Re: Lindstrom Residence
Lot 1450 Winterset Valley
25288 W 104th St.
Lee's Summit, MO 64081

Apex Engineers, Inc. has been asked to evaluate a structural revision proposed by the builder for the house located at the above stated address.

Figure 1 – Revised Suspended Slab Notes (Front Garage)

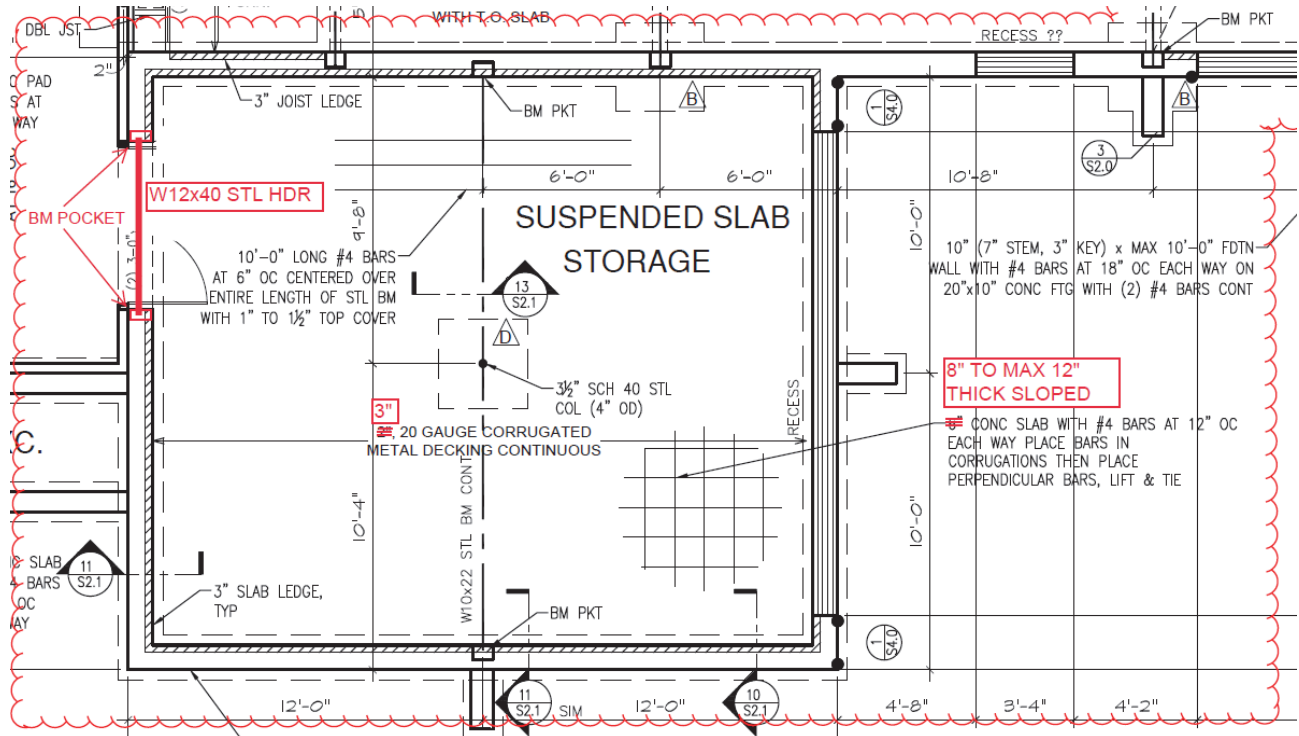
Specifically, the builder has requested to pour a thicker suspended slab (8" to 12") than originally noted on the plans, using a 3" instead of a 2" corrugated metal deck. This occurs at both the Front and Side garages.

Our firm has determined there are no additional changes required to the structure for the aforementioned request.
